Hydraulic Evaluation of Novato Creek Levees

September 2019

B: Stetson’s Review Comments on the HEC-RAS 1D/2D Model

C: Schaaf & Wheeler’s Revisions to the HEC-RAS 1D/2D Model

Unexplainable Flow Field in Pacheco Pond

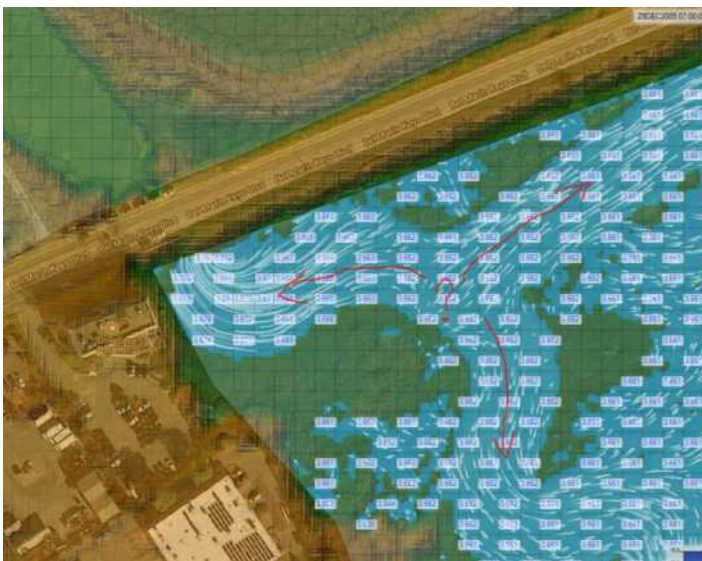
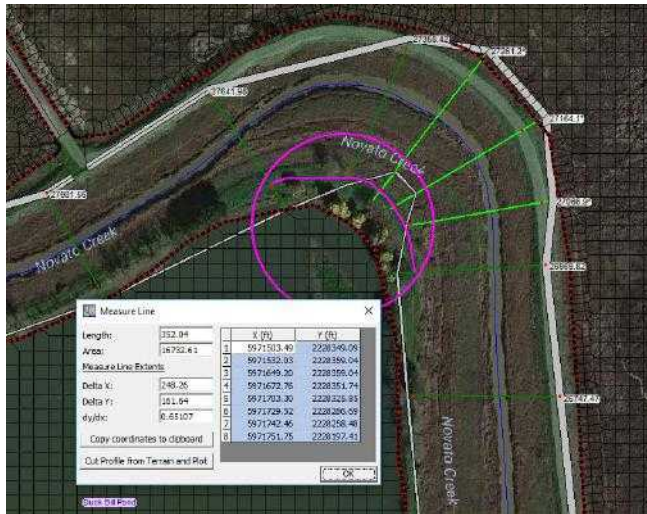
As shown in figure below, current model result (Plan: 100yrDesign) shows an internal inflow source to Pacheco Pond at the arrow-marked area, and Pacheco Pond WSE has increased from initial 3.55 ft at 0:00 to 3.7 ft at 7:00. However, examination of the model input flow file does not show any inflow source to Pacheco Pond. The model result is unexplainable and, thus, the model is not reliable for the evaluation of Pacheco Pond levee.

As shown in figure below, current model result (Plan: 100yrDesign) shows an internal inflow source to Pacheco Pond at the arrow-marked area, and Pacheco Pond WSE has increased from initial 3.55 ft at 0:00 to 3.7 ft at 7:00. However, examination of the model input flow file does not show any inflow source to Pacheco Pond. The model result is unexplainable and, thus, the model is not reliable for the evaluation of Pacheco Pond levee.

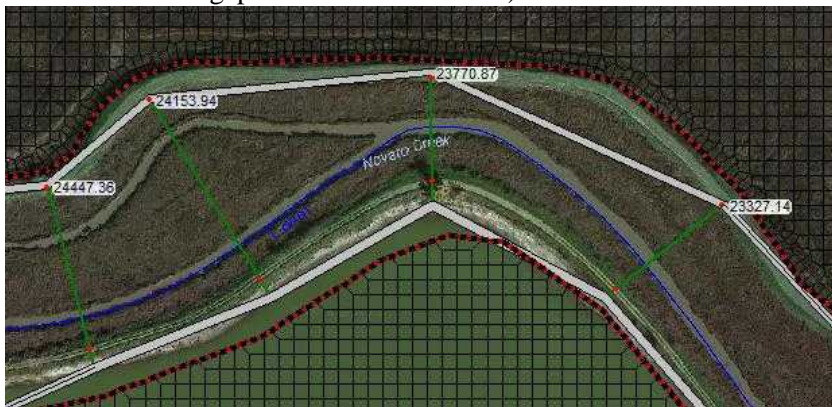
The model only sees the levee crest defined by the top of banks at XS locations and linearly interpolates levee crest between XSs. Any non-linear variation between XSs won't be seen by model, which may lead to incorrect overtopping calculations.

We have added cross sections cut from the same terrain model to better define lateral structure alignments, and the lateral structures are all now “snapped” to the top of bank locations, which have been individually verified as being at the appropriate cross sectional location. A schematic example of this technique is provided in the image below.

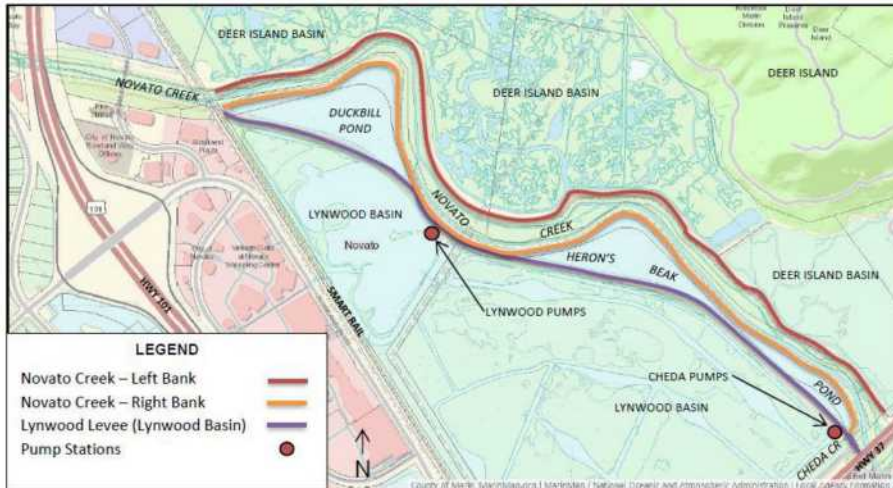
For example, there are two pump stations (see figure below), but the model does not have the pumps. The model also does not have a complete representation of culverts and tidal gates.

At County direction, we are not including pumps in the models used to evaluate the impact of Deer Island restoration on flooding. This makes particular sense for a FEMA analysis, because the pumps would likely be assumed non-operable for an Interior Drainage Study. Tide gates were initially coded in the model with a rule set to replicate backflow protection, but this has proven not to work entirely correctly in HEC-RAS. At the start of each time step, each rule set is evaluated to check for changed to the operation of a given hydraulic structure. But a rule set is only called once during a time step, even if the program iterates during that given time step, so the rule may not reflect the converged solution at the time step. This means we see backflow through the tide gate, for example, at Pacheco Pond when it should not occur. For this reason tide gates are assumed to be closed during flood events.

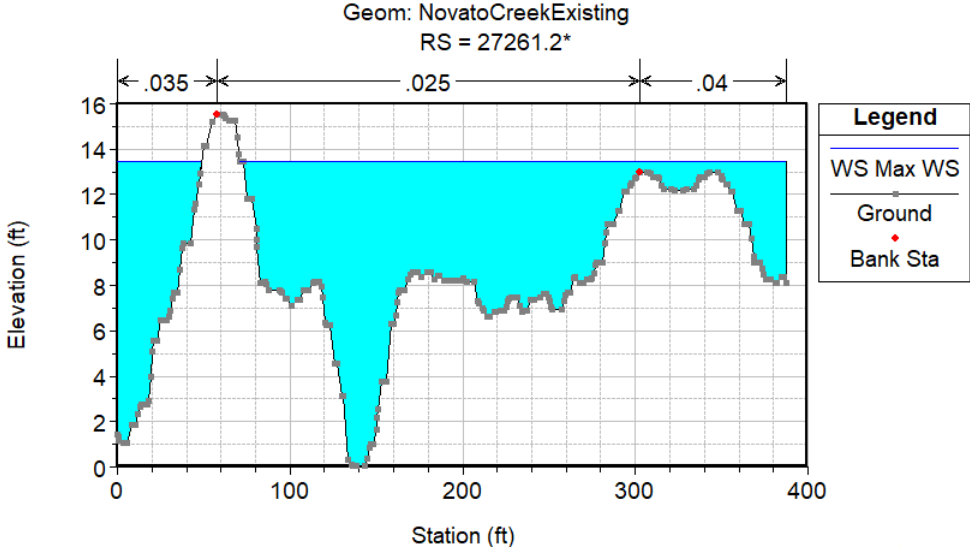
9. Incorrect bridge representations of HWY 101 Bridge and Redwood Blvd double bridges
- a. Refer to screenshots below, in reality, the HWY 101 has one single bridge and the Redwood Blvd has two bridges. However, the model represented these two bridges in an opposite way.
 - b. Both Bridges have skew angle with the channel, especially for Redwood Blvd double bridges, with a skew of > 45 degrees. However, the model does not skew any of these XS, and probably the bridge openings were not skewed either.

Bridge modeling at these two locations has been revised to include the cross section and bridge skew. Highway 101 is now modeled as a single bridge and Redwood Boulevard is now modeled as a twin bridge, using the data already included in the model.

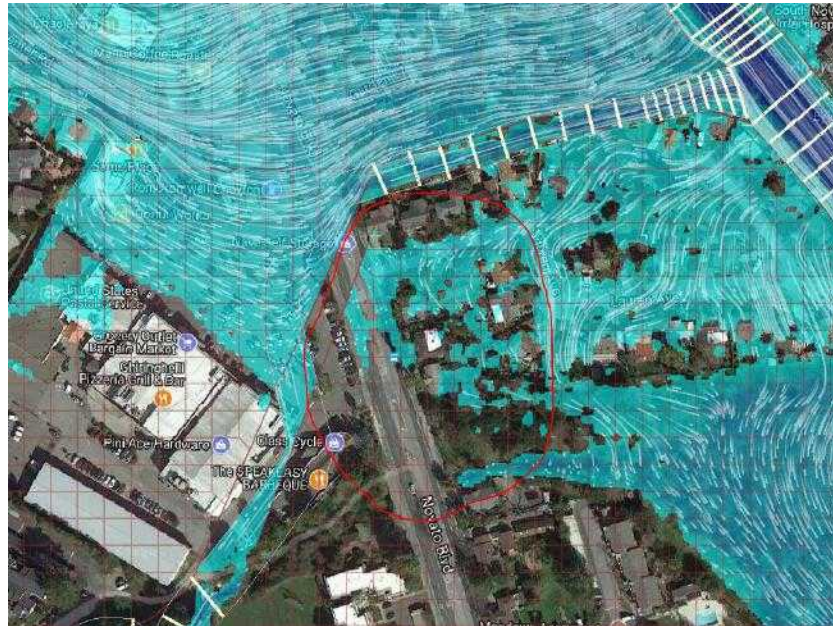
10. See figure below, the 1D in-channel model XS extends to outside of the levee, which creates an “artificial in-channel capacity” that may underestimate of in-channel WSE. (BTW, River stations in this model kept 2 decimal digits, which is unnecessary and complicate the reading of river stations. Rounding to integer is suggested).

Cross sections have been modified (points deleted) to eliminate flow conveyance in the channel direction beyond the limits of lateral structures, which are generally defined at the top of bank stations as shown in the figure above. Ineffective area boundaries are not sufficient for this purpose, as they would allow for the double-counting of storage, which is already accounted for in the 2D mesh.

C:\DATA\2690\GIS\Fig 1 Novato Creek Model Flow Input Locations.mxd 7/20/2018

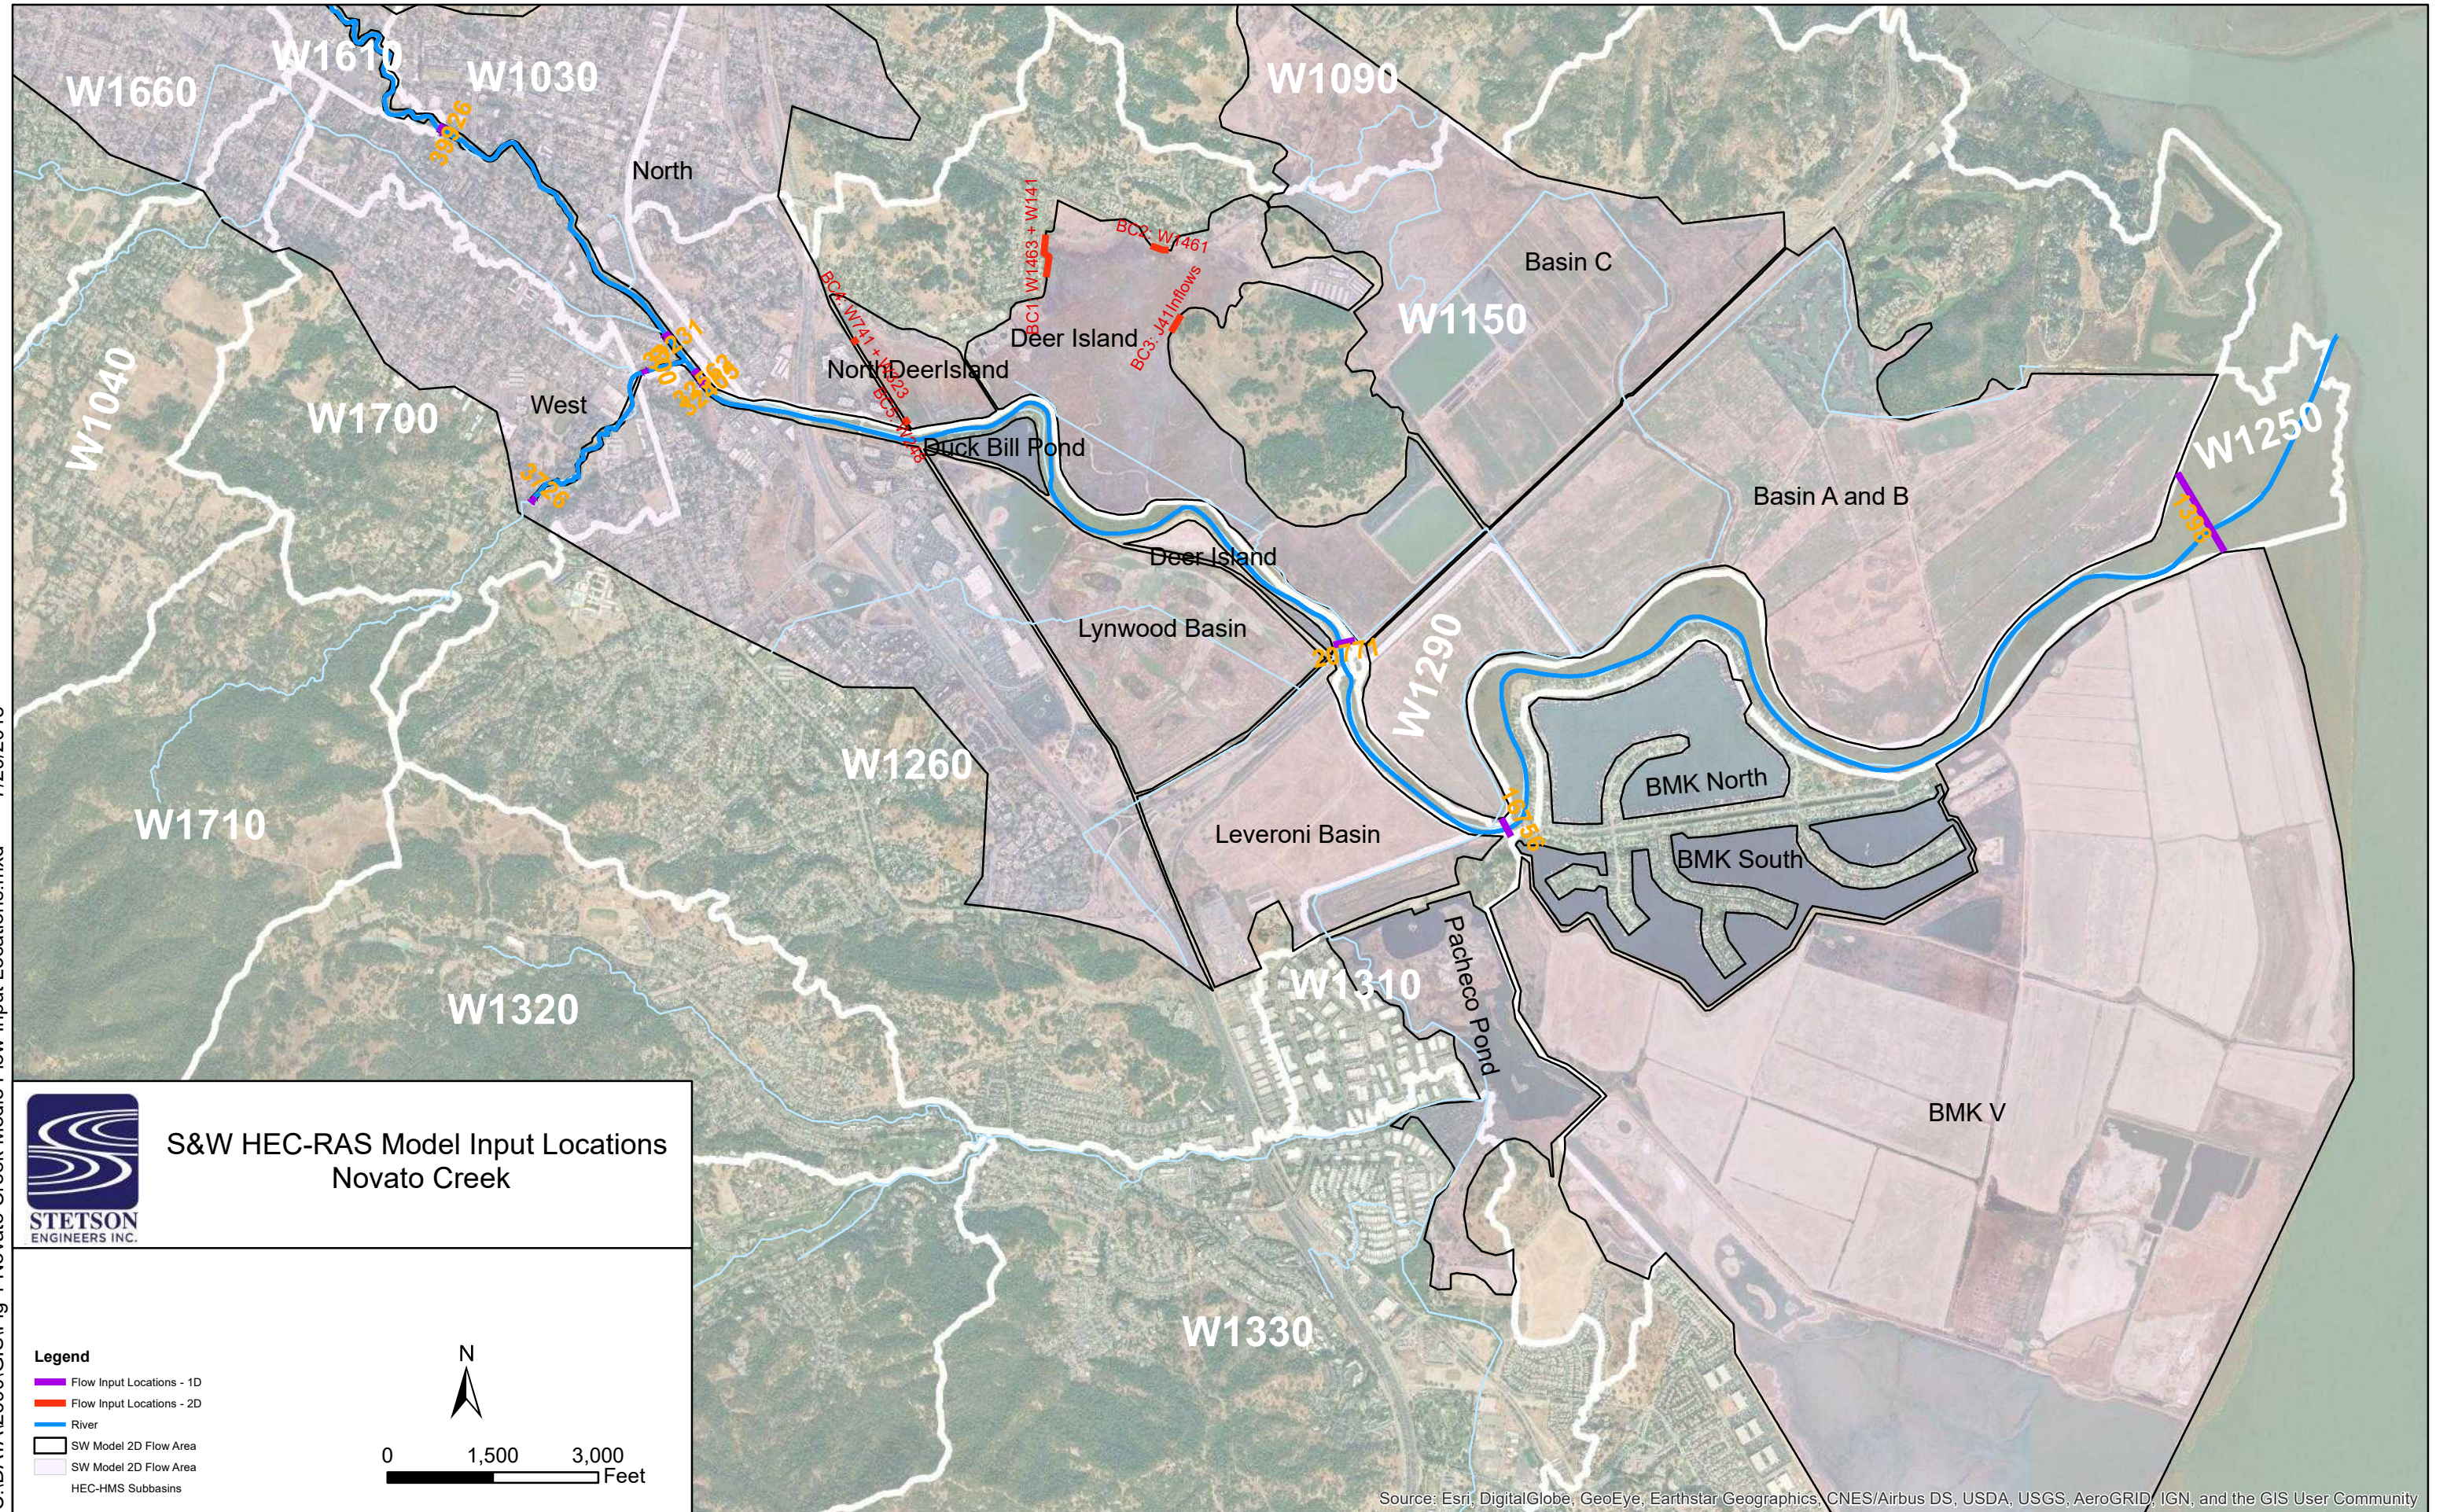
Refer to Figure 1 in attached PDF file flow input locations of the HEC-RAS 1D/2D model. The model lacks of flow inputs to Pacheco Pond and Lynwood Pond, which would affect the evaluation of levees along these ponds. Other flow input locations also need be adjusted as well for accurate representation of the system.

2D Flow Area Boundary Delineation

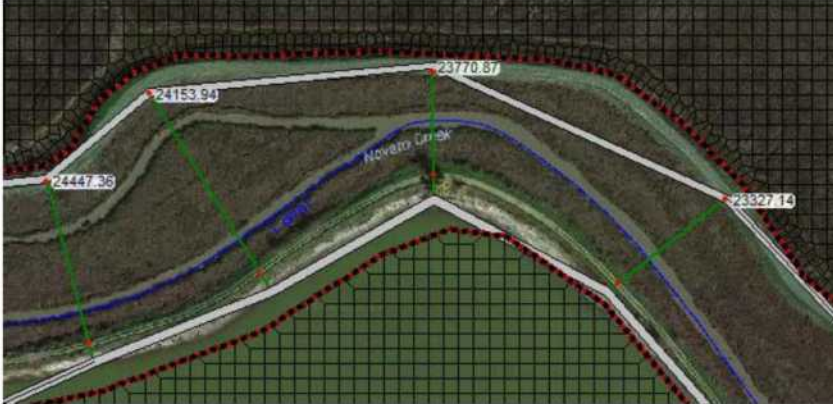
The 2D Flow Area boundary delineation does not cover the entire pond, which leads to underestimate of pond capacity, and also creates gaps that will never be inundated during inundation mapping (Note: During the review of the Ross Valley HEC-RAS 1D/2D model, USACE reviewer specifically pointed out that such gaps need to be corrected).

The 2D flow mesh boundaries have been adjusted to match the bounding lateral structures. This does cause model error where ground elevations in mesh cells adjacent to lateral structures are higher than the defined elevation of the lateral structure, so the lateral structure elevations are adjusted to be infinitesimally higher than the adjacent terrain.
